**Site Screening Process Investigation  
Work Plan for Sites 19, 26, 27,  
Wetland Area Adjacent to Site 45, and  
Stump Neck SWMUs 14 and 30**

Naval District Washington, Indian Head  
Indian Head, Maryland

Contract No N62470-02-D-3052  
CTO-0050

**FIGURE 6-1**  
**SITE 26 PROPOSED SAMPLE LOCATIONS**  
SSP INVESTIGATION WORK PLAN, CTO-050  
NDWIH, INDIAN HEAD, MARYLAND

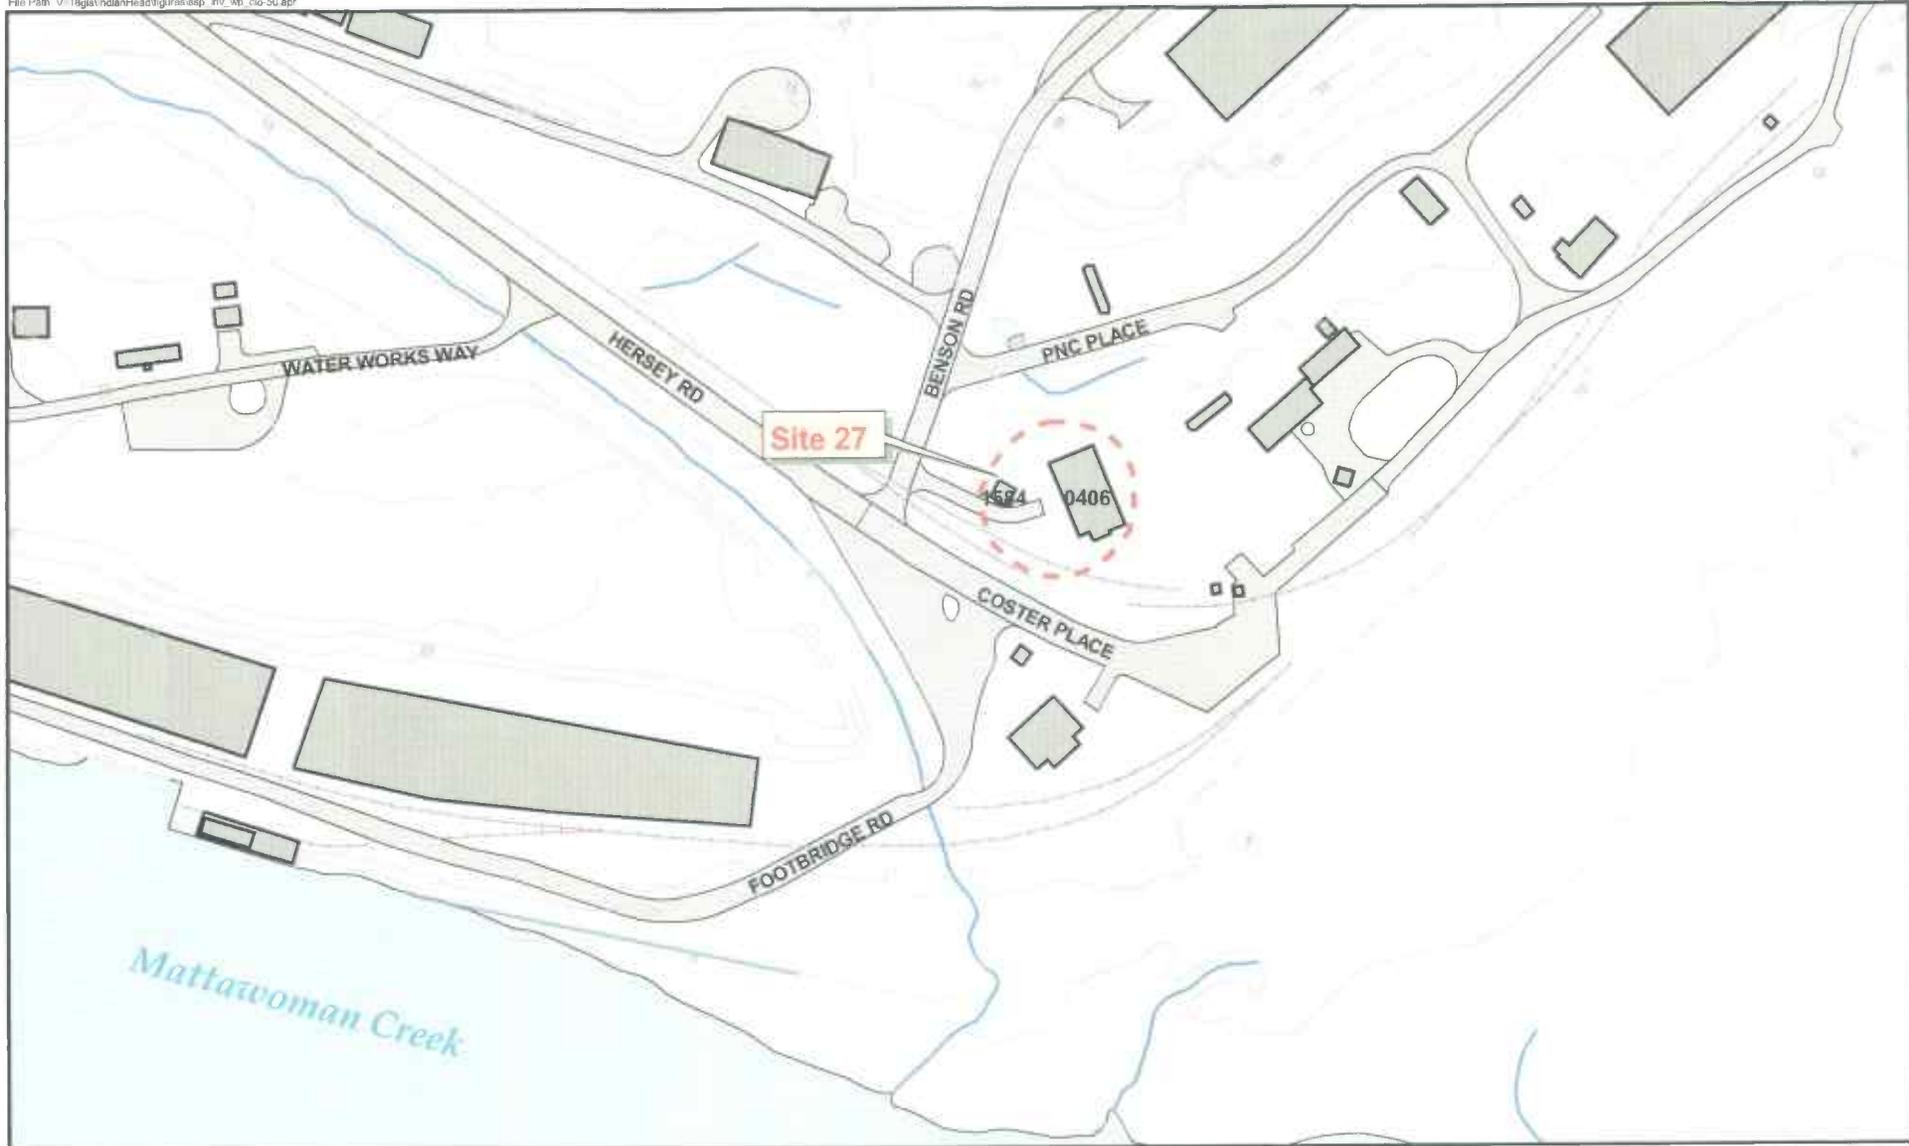
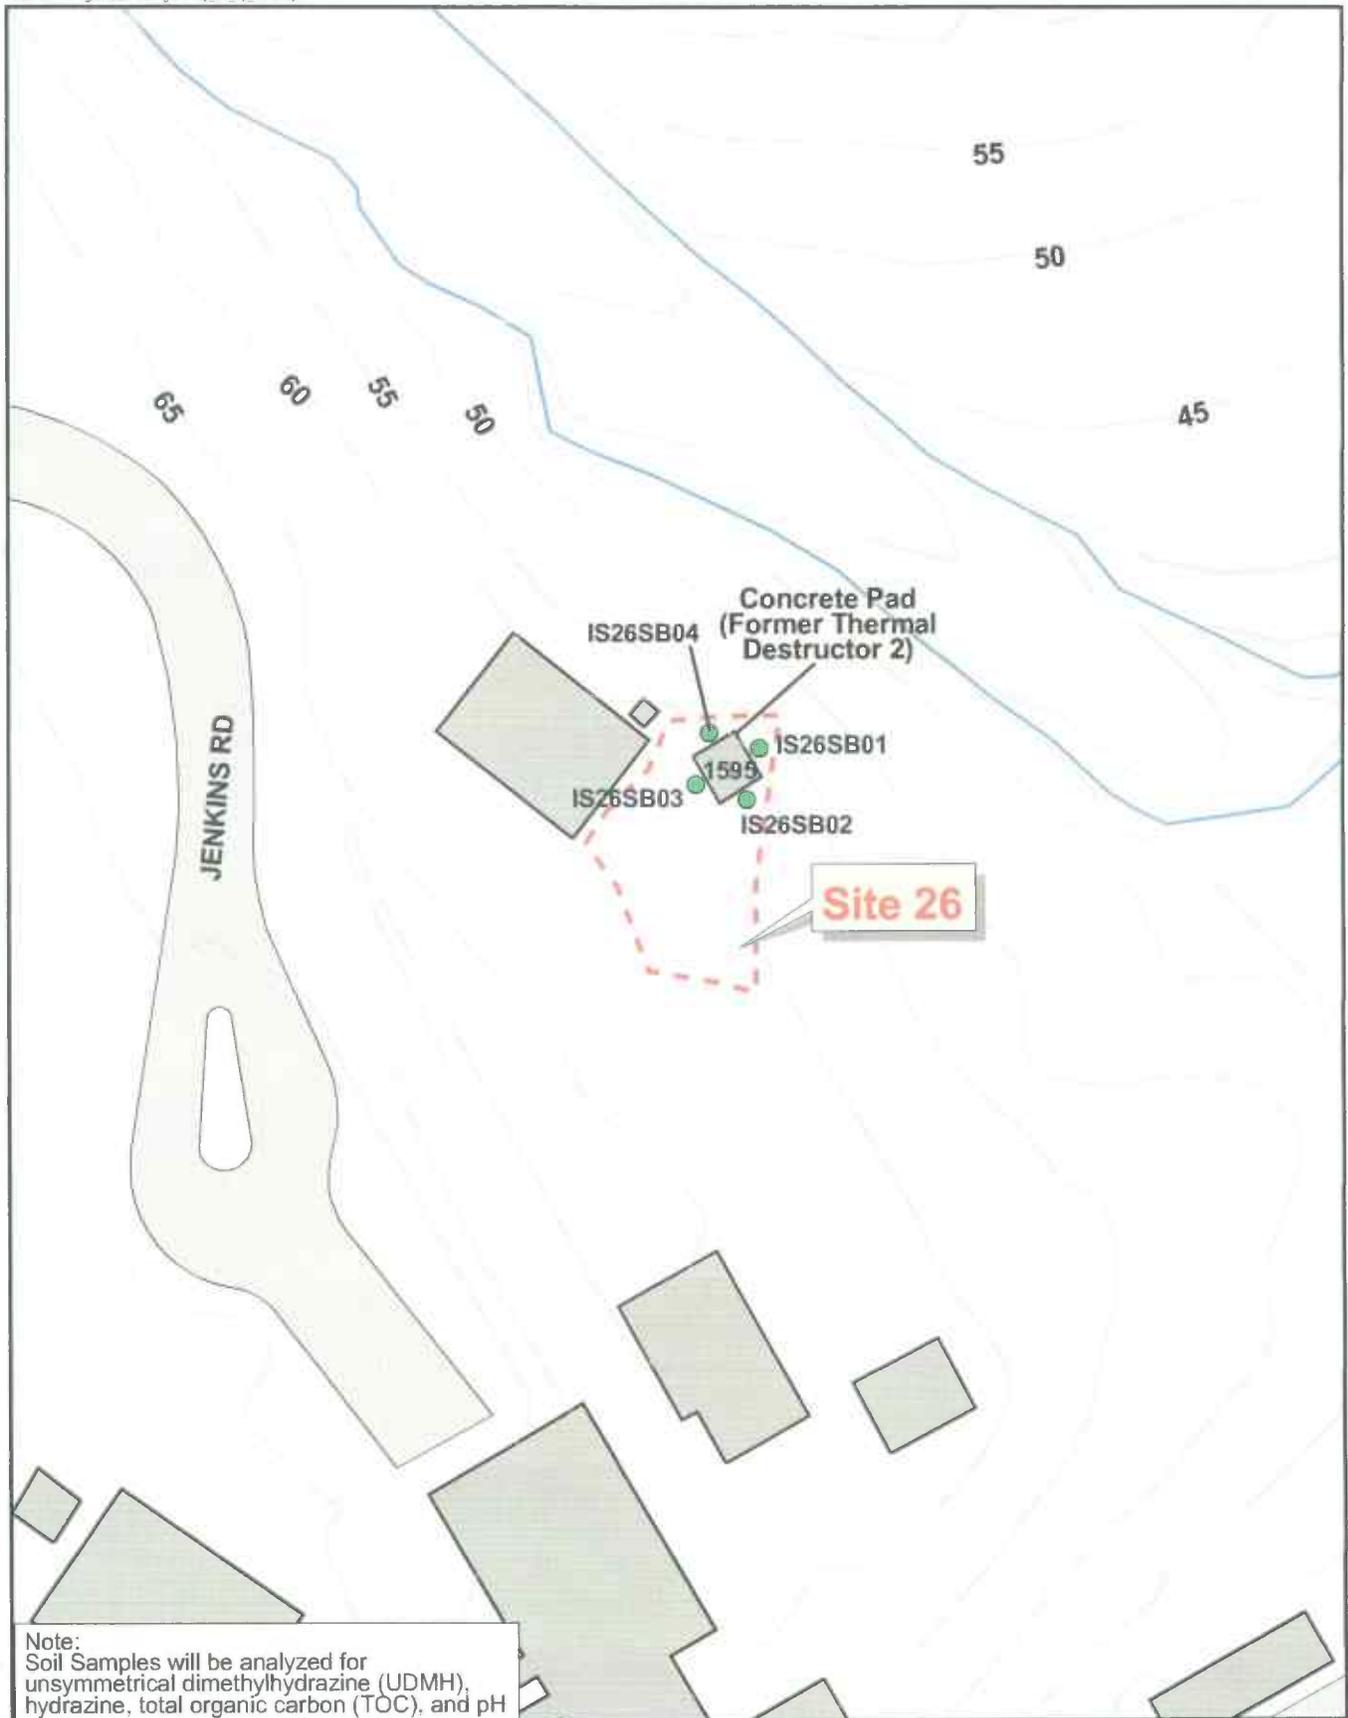
1. Shawn's Comment #10. We have not yet addressed this comment, which applies to Figures 1-6 and 6-1. Please see the question below regarding Shawn's Comment #28.

5. Shawn's Comment #28. This comment indicates that Buildings 1595 through 1598 were demolished in 2001 and that Building 1599 still exists. The comment infers that the concrete slab for Building 1595 remains but that the slabs for Buildings 1596 through 1598 have been removed. Please confirm. We have used the information in Comment #28 to address the text in Section 6.1, but as noted above we still need to incorporate this comment into Figures 1-6 and 6-1.

FIGURE 2-1  
DATA EVALUATION PROCESS FLOWCHART  
SSP INVESTIGATION WORK PLAN, CTO-050  
NDWIH, INDIAN HEAD, MARYLAND

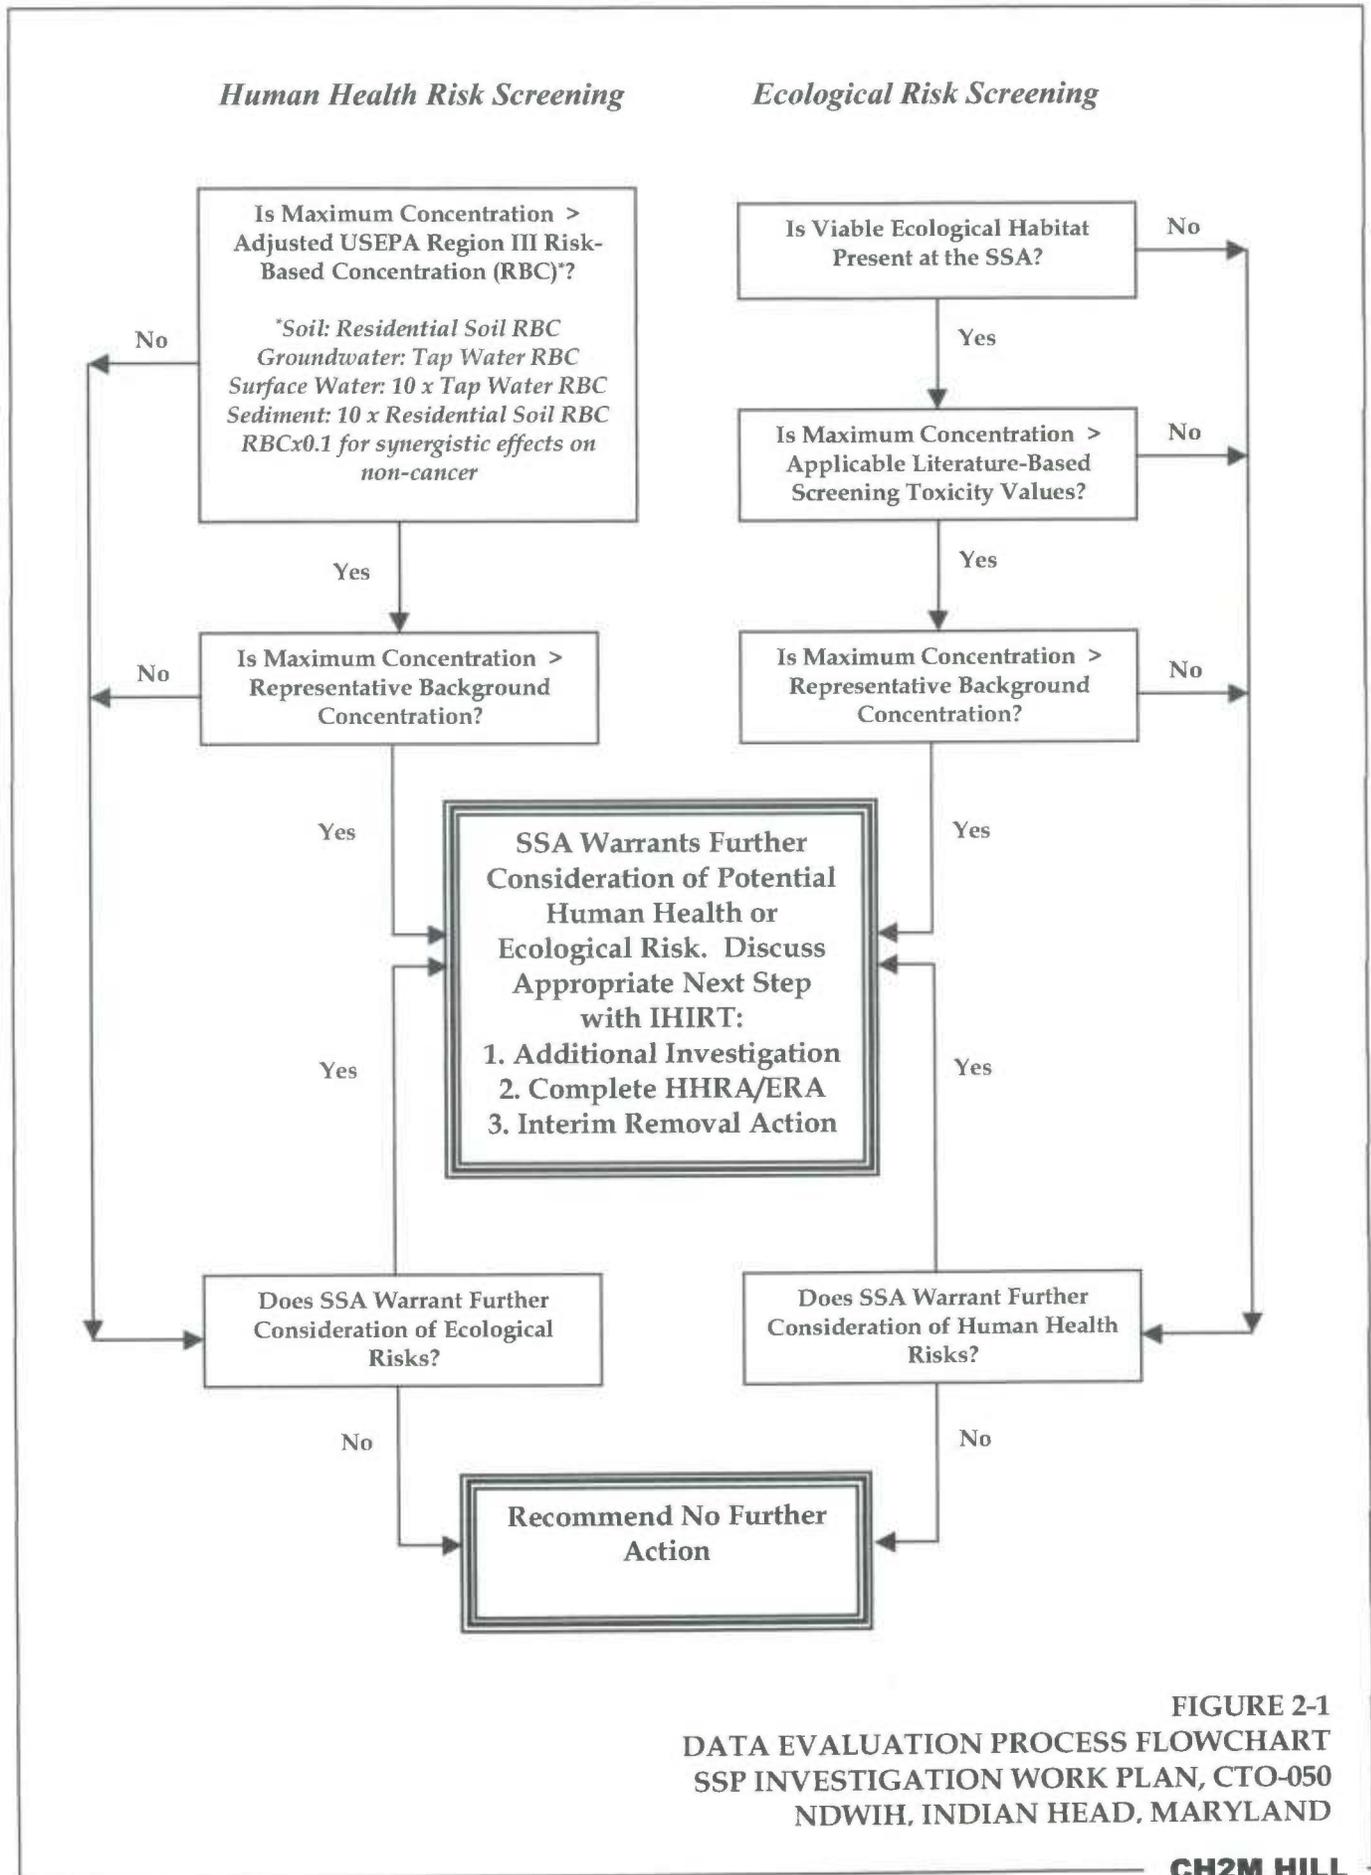
The rules do not allow for any refinement of the data. For a simple example, if only a single exceedance is identified, it might not necessarily force further investigation. Some additional criteria should be included to avoid moving a site up to the next level when there is really sufficient information already available or it would take minimal effort to obtain such information to close it out. On the other hand, if the data indicates either an imminent risk or an easily-remediated hot-spot, there should be decision rules to address these. (Note: Figure 2-1 does this, although the text is silent on these possibilities.)

Since the decision stated in Step 2 is to determine if a BERA is required or if the site may be closed out, the reference to Figure 2-1 may not be necessary if the outcome of the above two comments regarding human health risk is that only ecological risk will be considered.

The last paragraph on this page states that chemical concentrations will be compared to background concentrations and, if they exceed background, they will be compared to ecological screening criteria. However, Figure 2-1 shows concentrations will be compared to ecological screening criteria first, then to background if they exceed screening values. The document should be revised to make the figure and text consistent with each other, as well as with the current EPA policy and guidance on background comparison.

**RESPONSE:** The text in Section 2.3.5 is currently silent on these possibilities and will be modified as described later in this response. Please note that the decision rules depicted in Figure 2-1 are described in Sections 1.1 and 2.5 of the SSP Investigation Work Plan.

**RESPONSE:** The reference to Figure 2-1 (the last sentence) will be removed from this section.
